AIRWORTHINESS ADVICE NOTICE

TYPE AFFECTED: Jantar and Jantar Standard. All variants.

SUBJECT: Miscellaneous airworthiness information.

FIGURE 1. LOCKING WASHER SECURITY

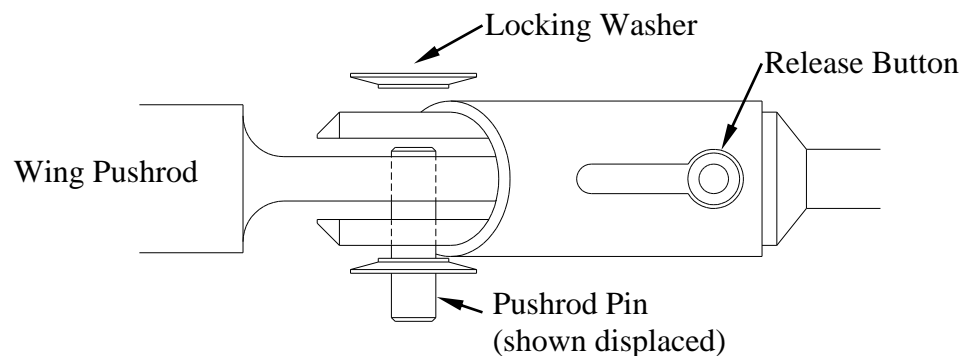
Experience has shown that the locking washer on the connecting pin in the elevator and/or aileron connectors may work loose allowing the control to be connected incorrectly as shown in fig. 1.

Should the locking washer be loose then the defect must be rectified before next flight.

The defect may be rectified by either replacing the washer with a new part (the best option) or by cold forming the washer until the hole is between 5.980 and 5.990 mm diameter.

Cold forming should be done by either pressing flat between plates or by placing a steel ball (~ 20 mm ø) on the hole and then tapping with a hammer. If using the steel ball method the washer should be turned over and the process repeated.

Before pressing the washer on, the pin diameter should be checked for the correct size of 5.992 to 6.000 mm diameter.

FIGURE 2. POSSIBLE AIR BRAKE JAMMING

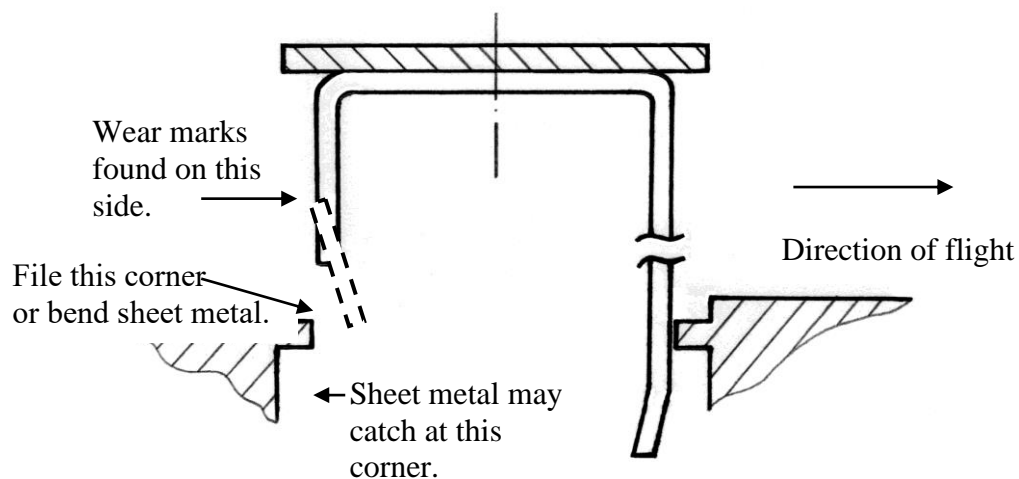
3. Scratch marks on the backside of the airbrakes were found on two Standard Jantars (1 and 3). With only little force it was possible to jam the airbrakes when they were extended. So far no incident has been reported but it is strongly recommended to check the airbrakes to prevent possible jamming and perform corrective actions if required (ie. Bevel (file) the corner or slightly bend the sheet metal). See figure 2.

Fig.1.

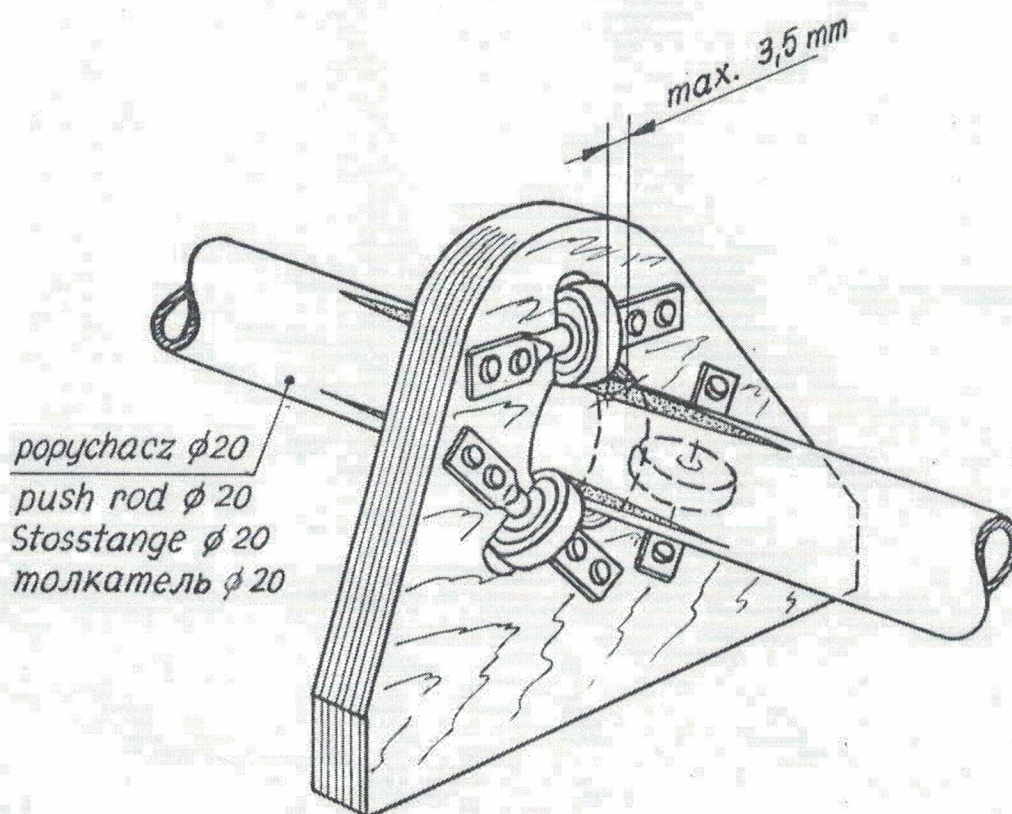
5.1. The allowed limit width of the roller "trace" on the push-rod surface is 3,5 mm (Fig.1).

5.2. In case the allowed wear value is exceed (even on one place-only) - disconnect the control system and turn the push-rod by 180° . Then secure it and check the adjustment.
